#### **ADDENDUM #4**

PROJECT : CODESTACK ACADEMY

REF. # : ARCH PROJ. No. 2023-04

DATE: 11 March 2025

S2.1

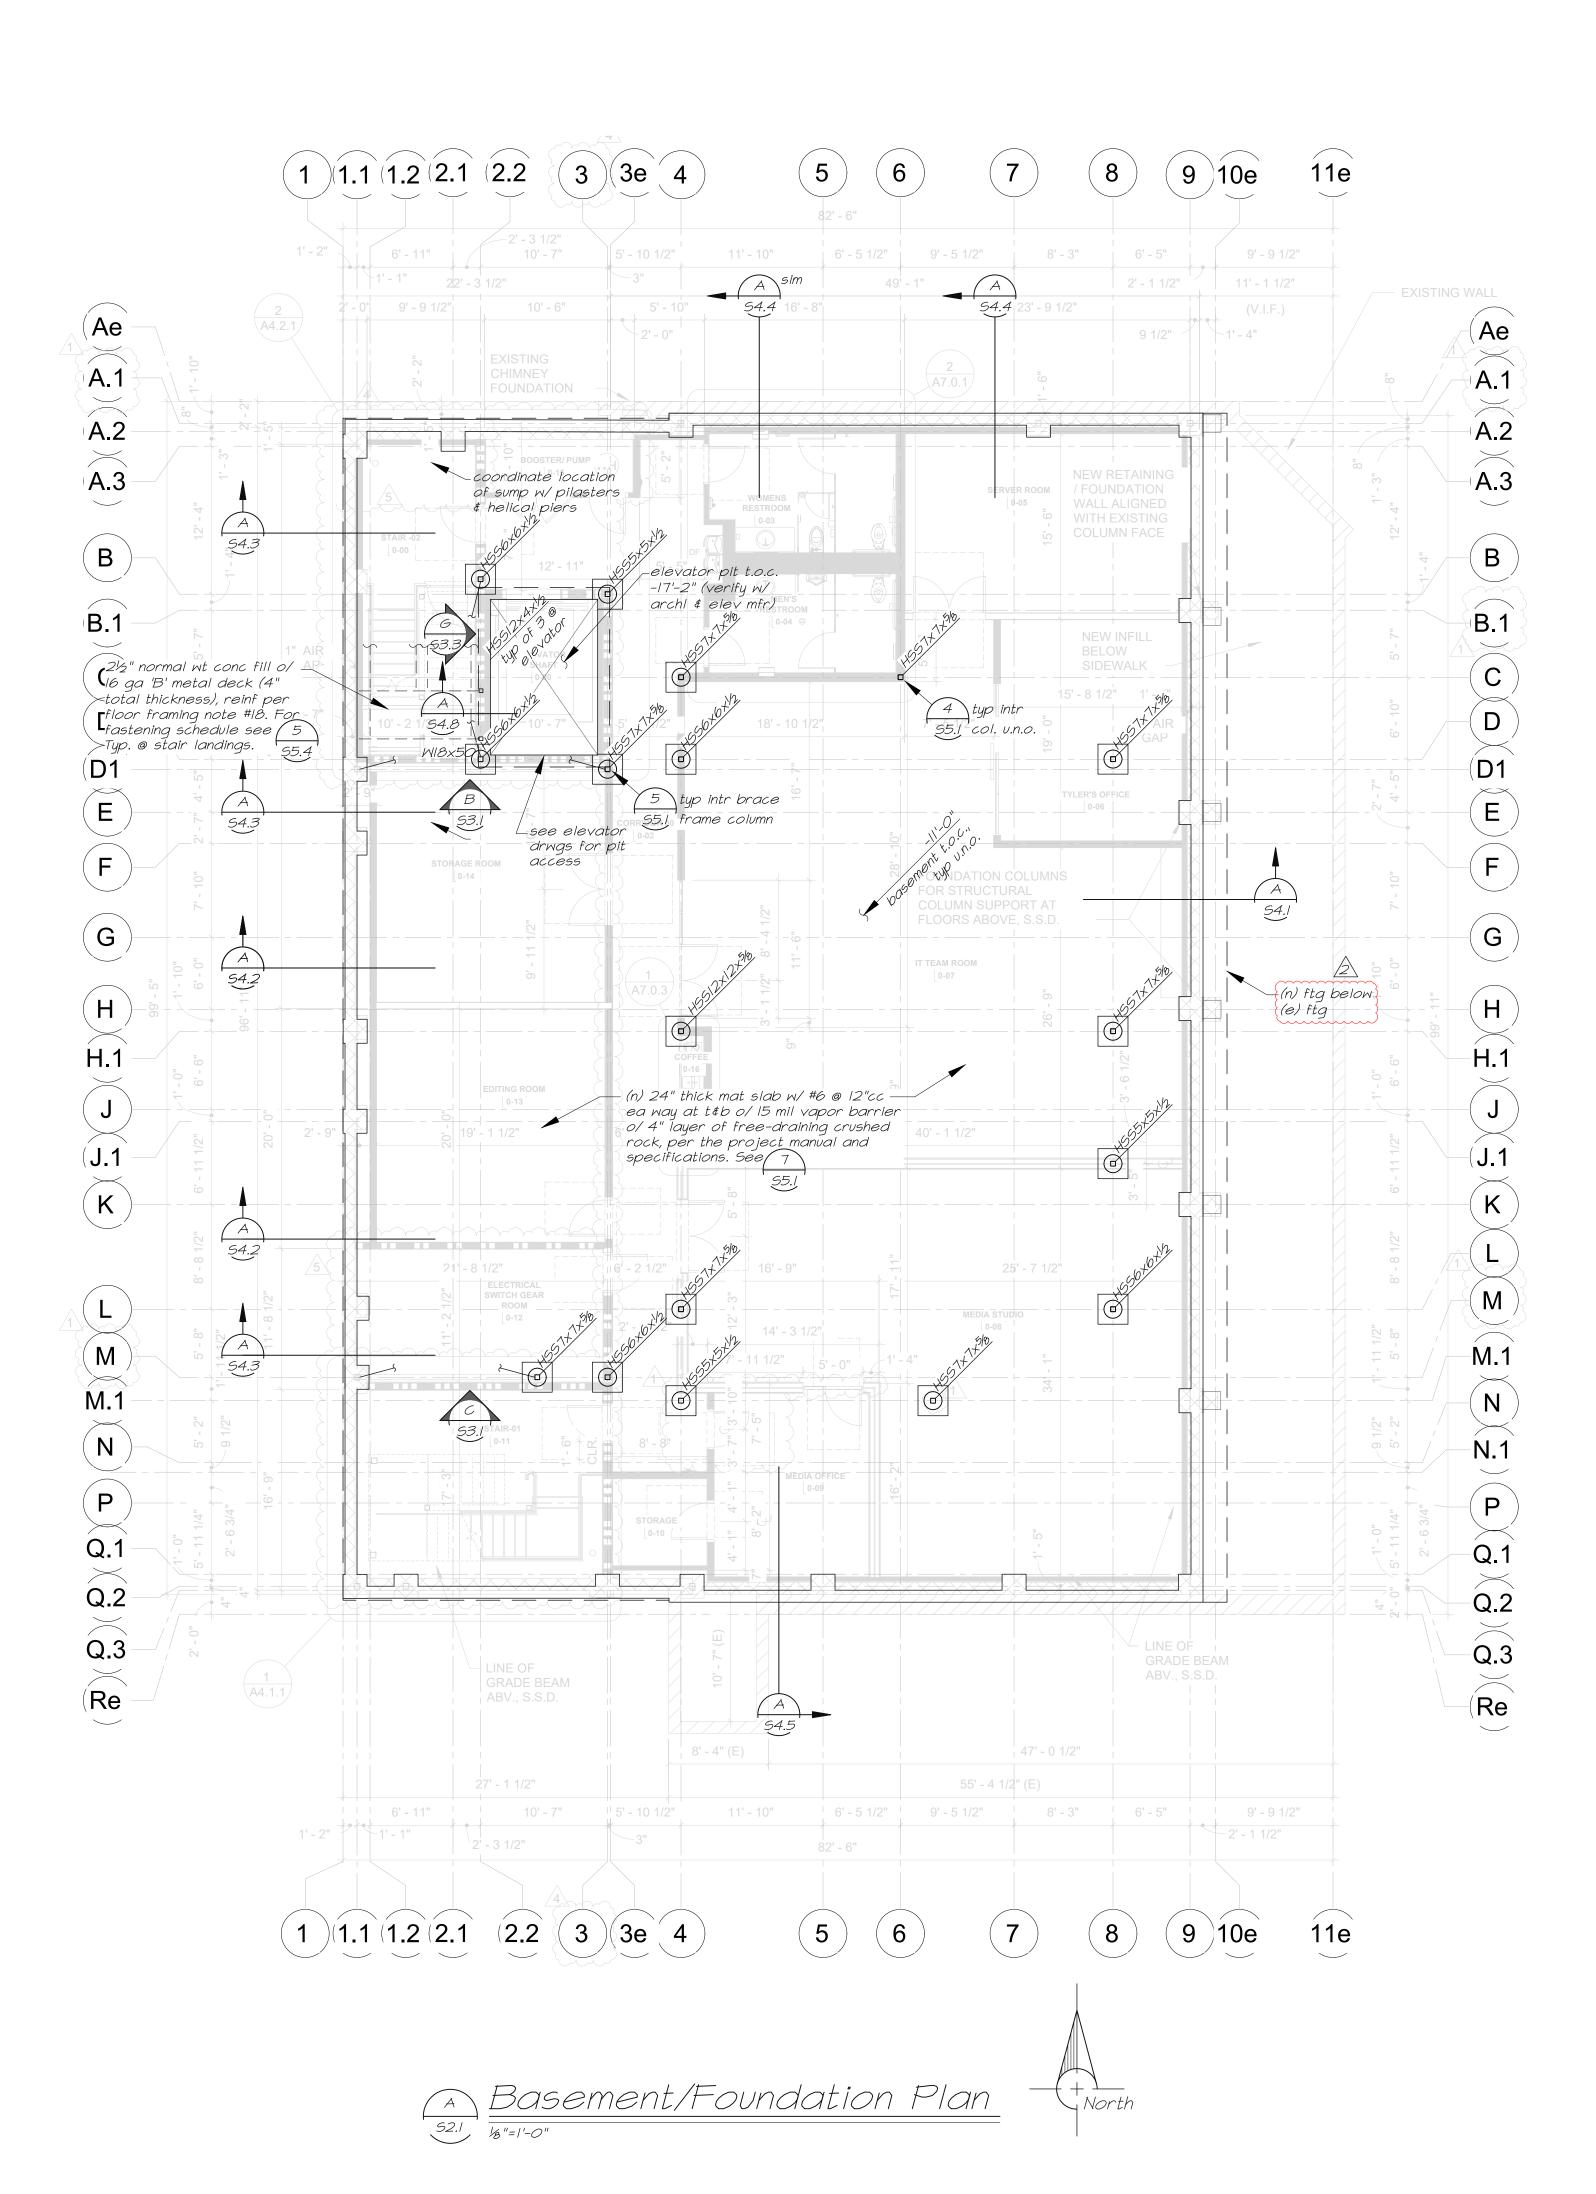
ITEM 33 Drawing sheet: S2.1 (attached)

**DESCRIPTION:** Showed on plan the extent of footing shown in section A/S4.1.

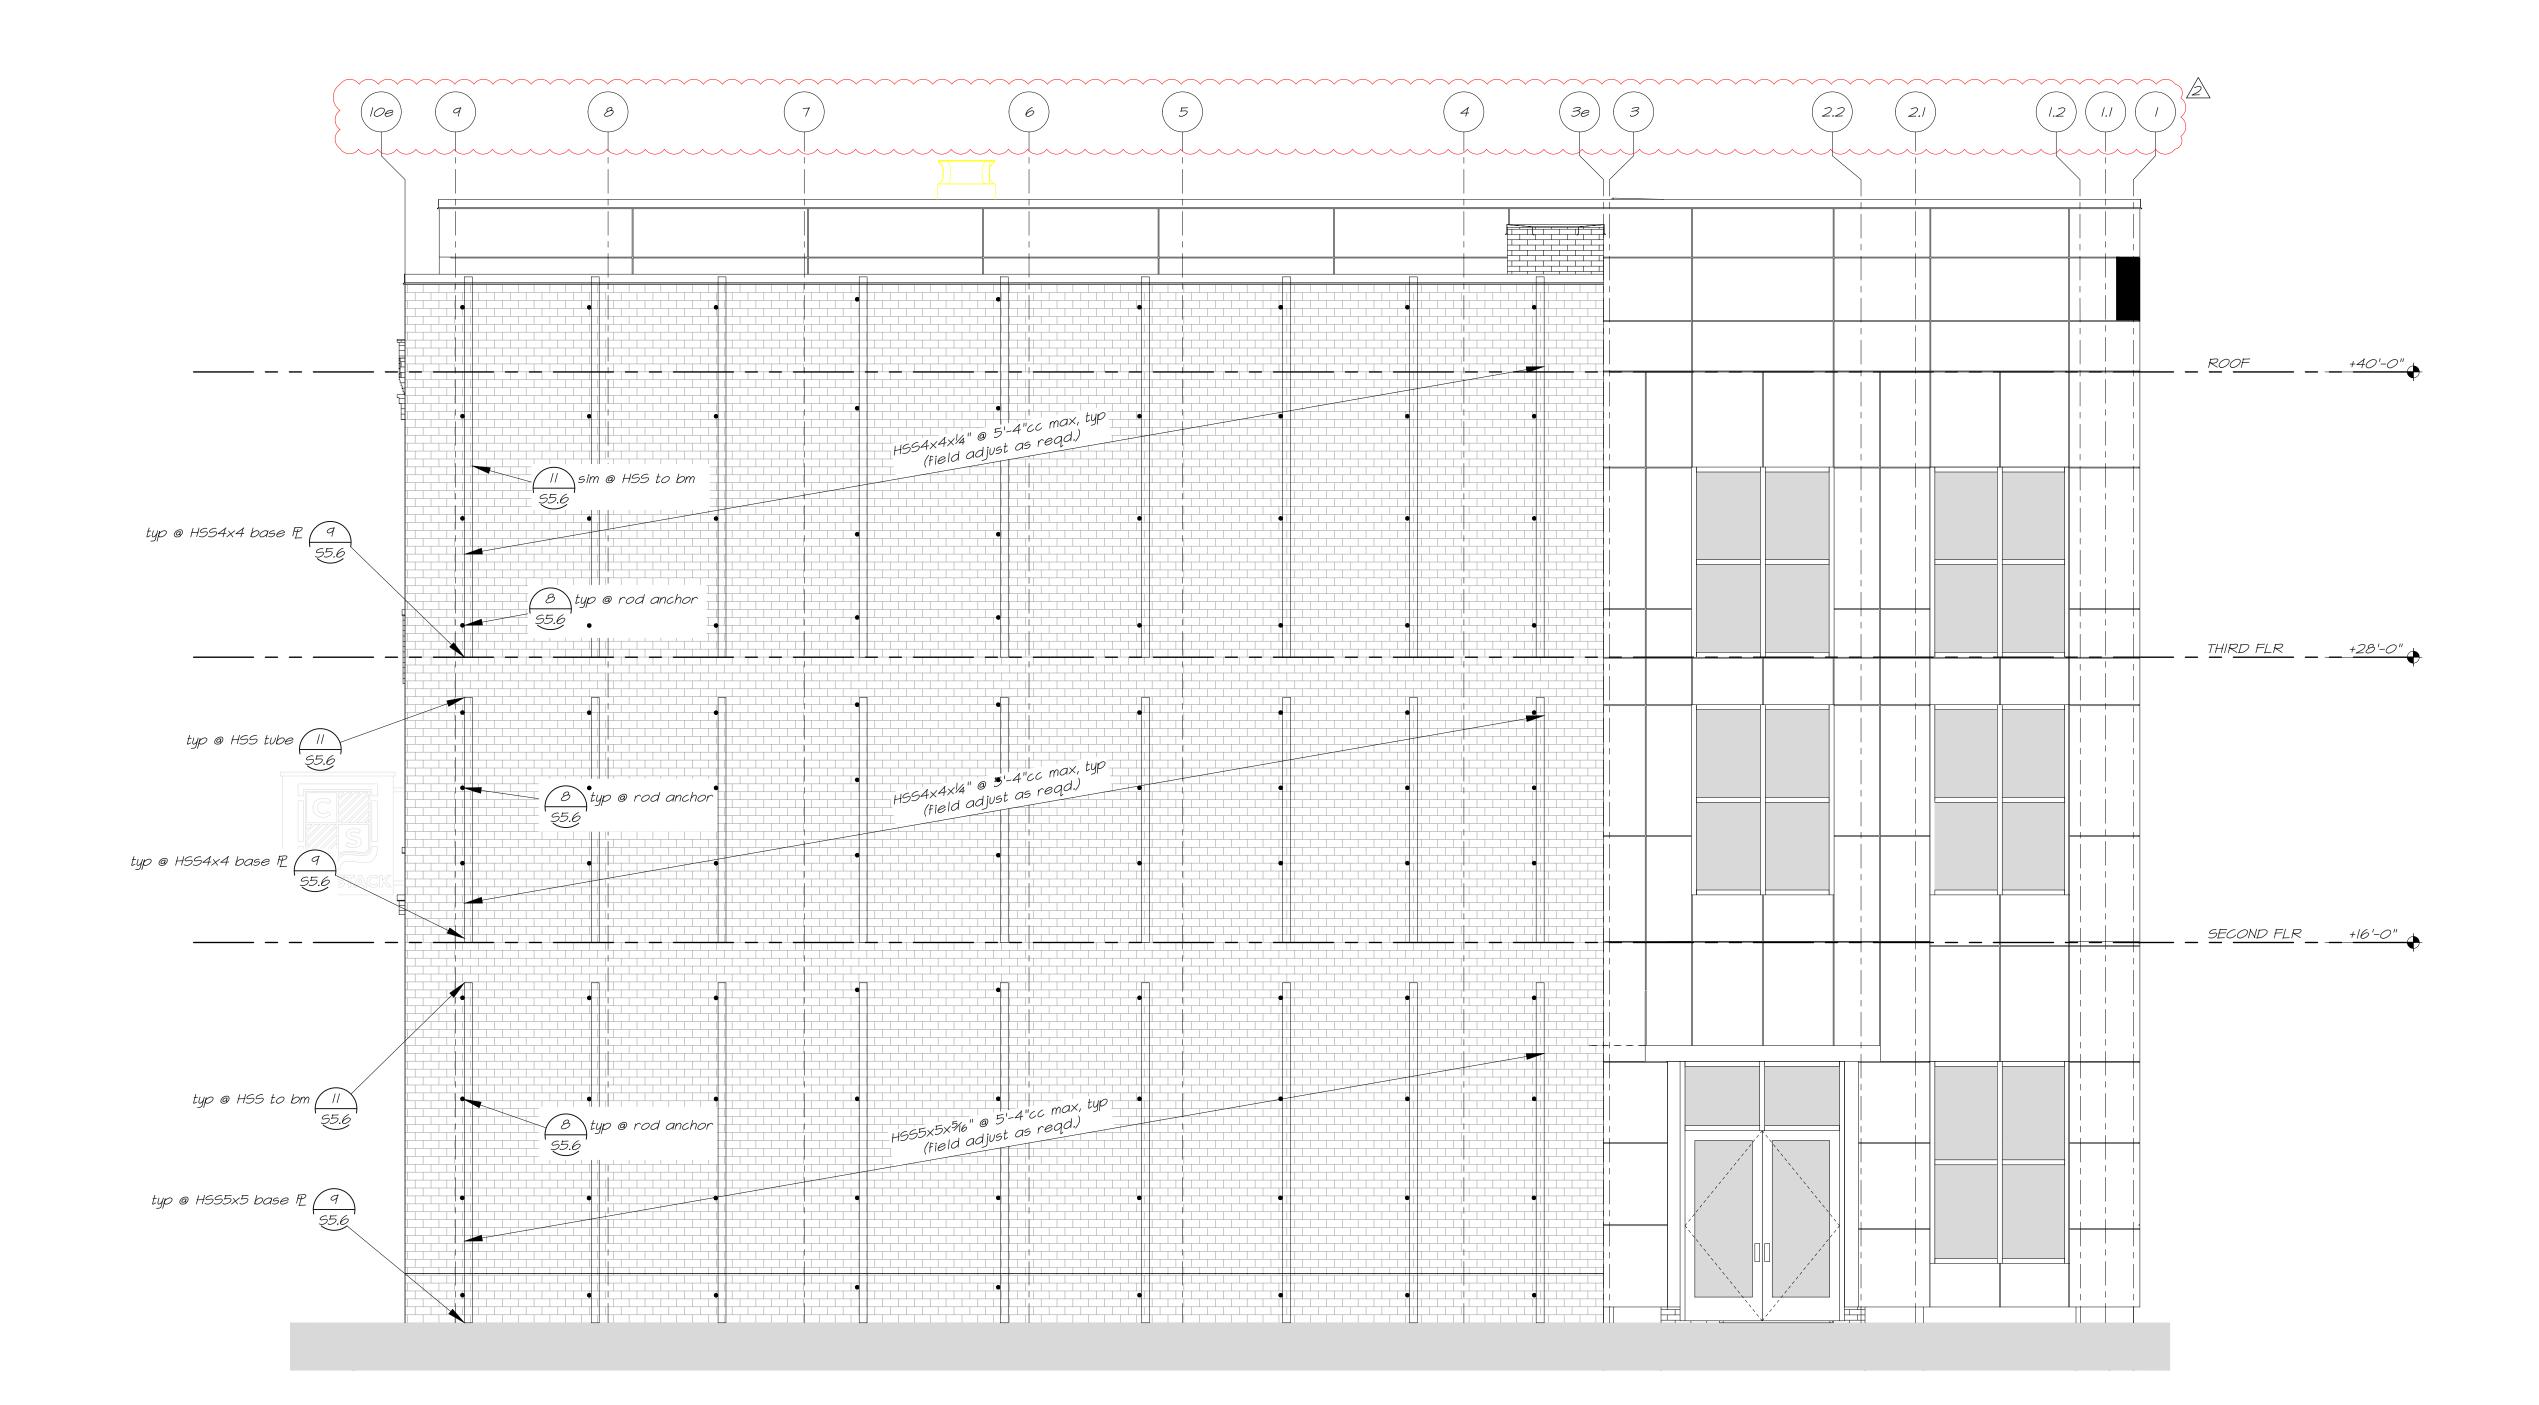
ITEM 34 Drawing sheet: S2.2 (attached)

**DESCRIPTION:** Showed on plan the existing brick wall along grids Ae, 10E, and Re.

S3.6

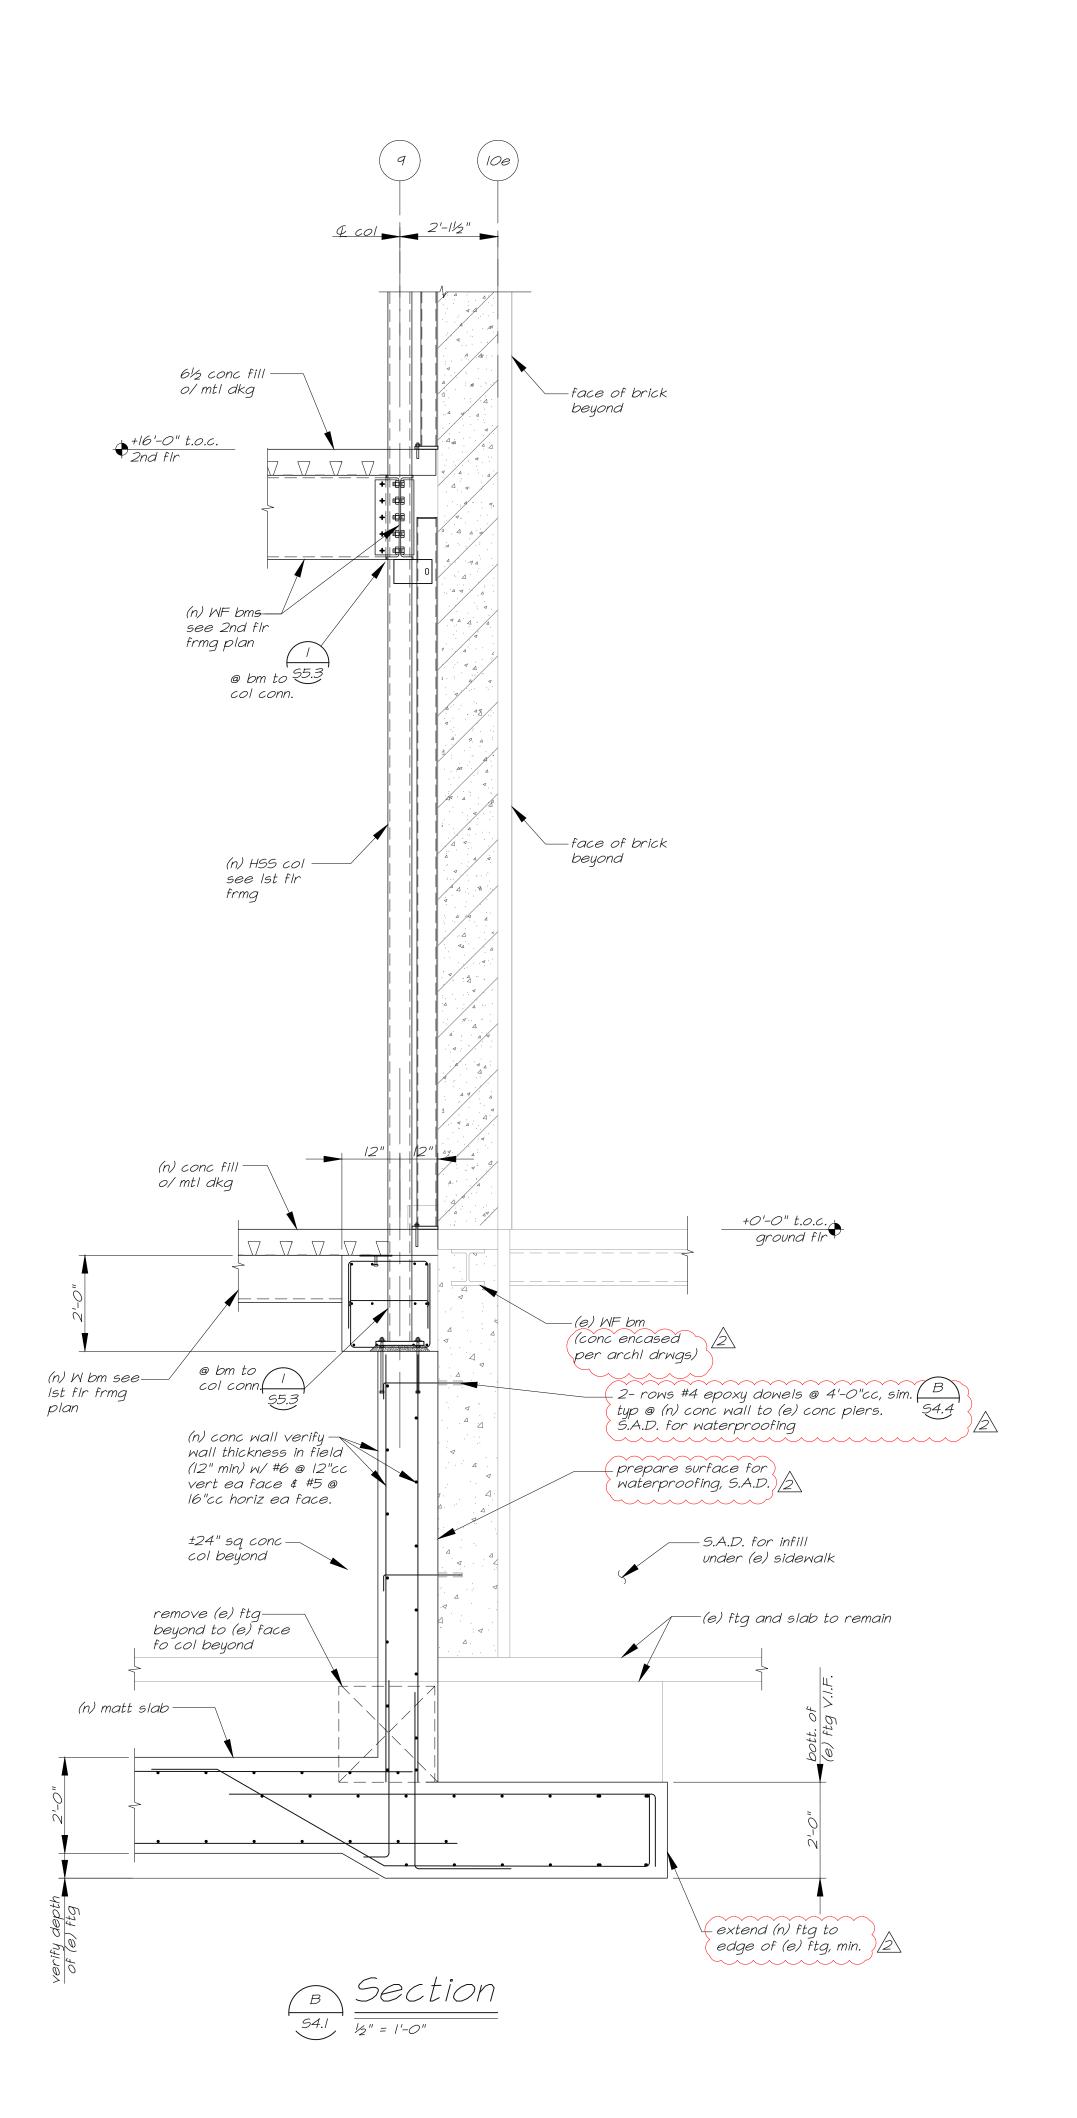
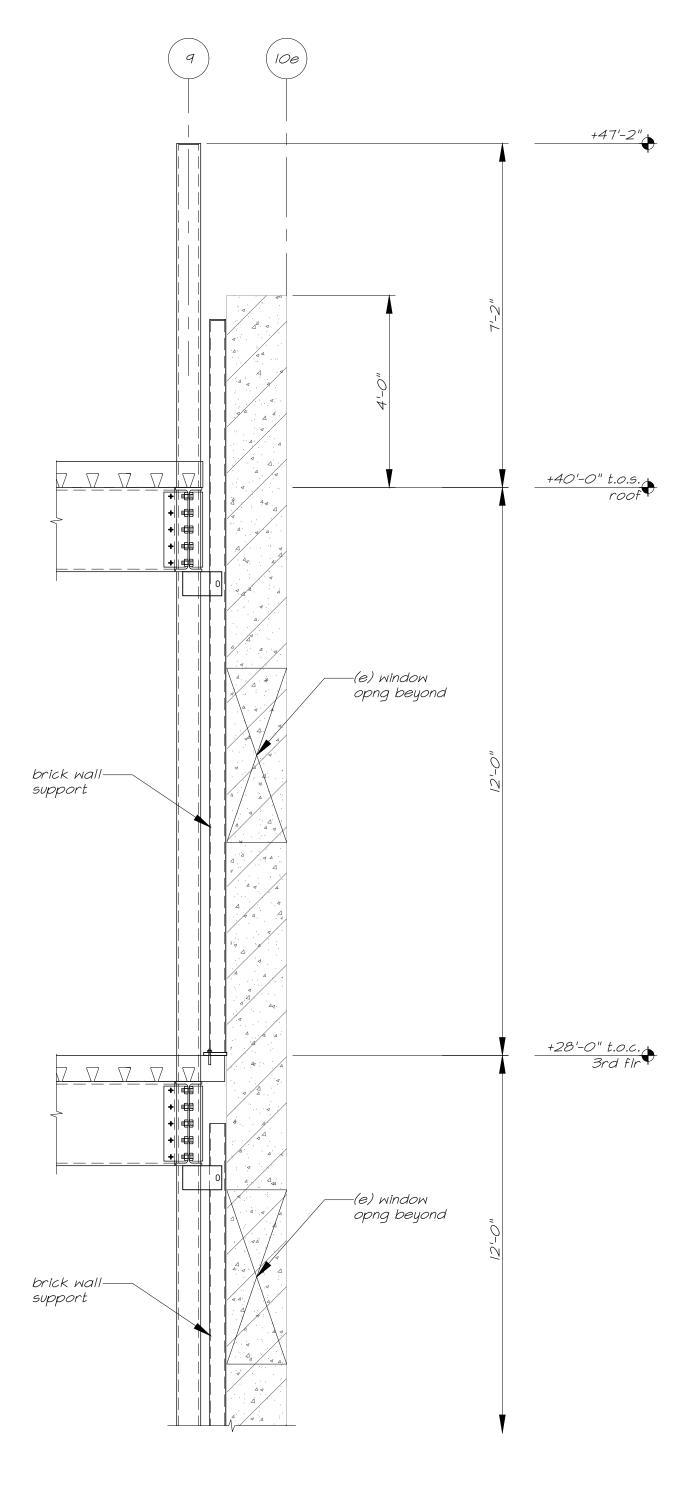
ITEM 36 Drawing sheet: S3.6 (attached)

**DESCRIPTION:** Corrected Grid numbering, and brick hatch added.
